**Eastview Recreation Center  
Administration**

**Assessment October 23, 2018**

# ADA Checklist for Existing Facilities

**Project:** Greeneville TN ADA Assessment

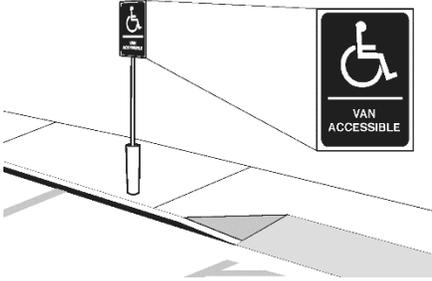
<p><b>1.4</b> Are accessible spaces at least 8 feet wide with an access aisle at least 5 feet wide?</p> <p>[502.2, 502.3]</p> <p>Note: Two spaces may share an access aisle. Check state/local requirements; some specify that each space have its own aisle.</p>	<p>No at side of building</p> <p>Measurement: No aisle</p>		 <p>Photo #:</p>	<p>Mark access aisles</p> <p>Budget Year: 2020</p> <p>Cost: \$50</p>
---	--	--	---	--

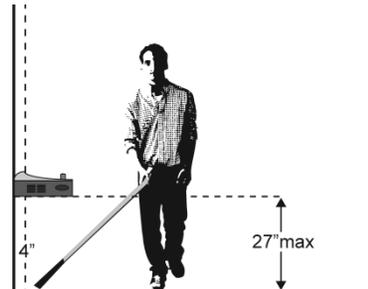
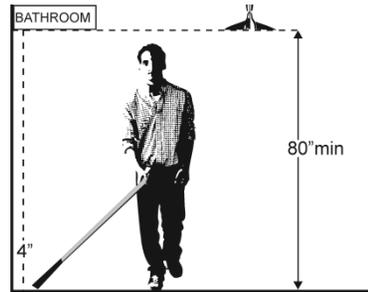
**2.8** Do all objects on circulation paths through public areas, e.g. fire extinguishers, drinking fountains, signs, etc., protrude no more than 4 inches into the path?

No

Add tactile warning such as cane skirt, permanent planter or partial walls

Photo : Men's Toilet Women's Toilet is similar

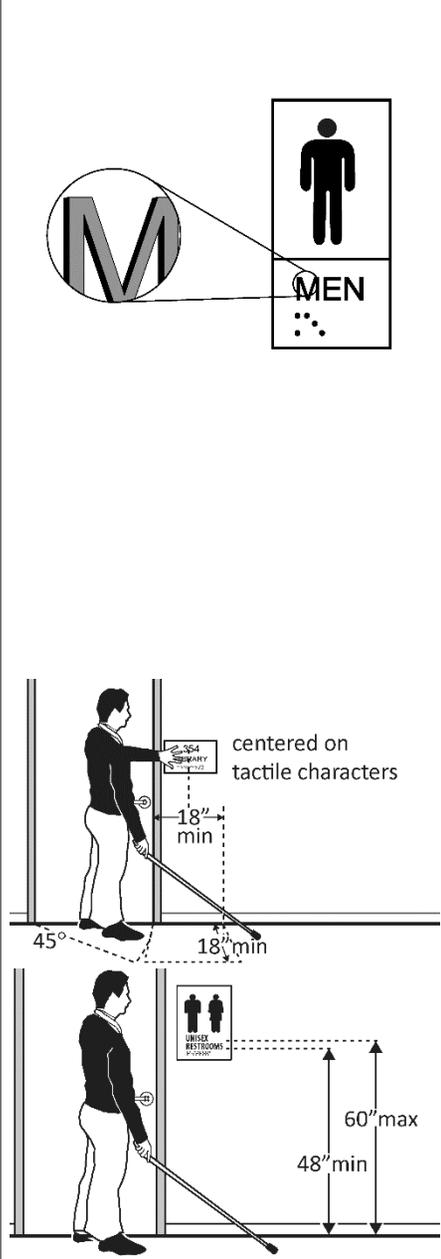
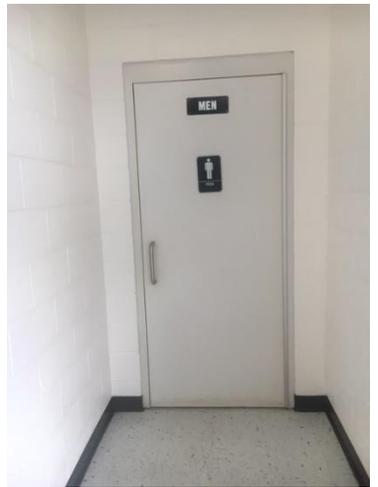
No

No

Doors swing in

- Install tactile sign
  - Relocate sign
- Budget Year: 2020
- Cost: \$100

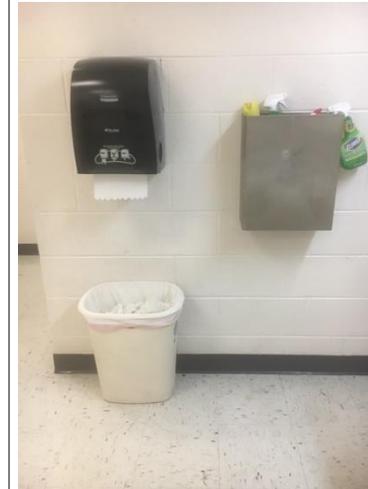
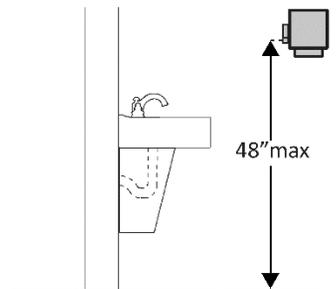
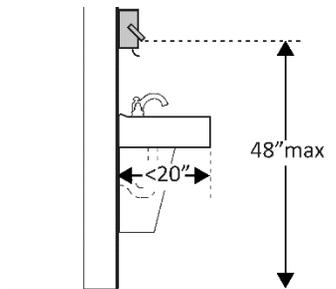
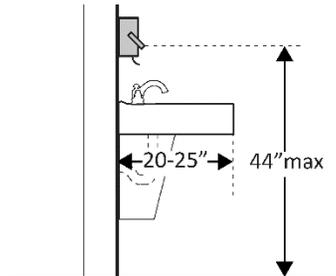
**3.29** Are the operable parts of the hand dryer or towel dispenser within one of the following reach ranges:

- Replace with or provide additional accessible dispensers
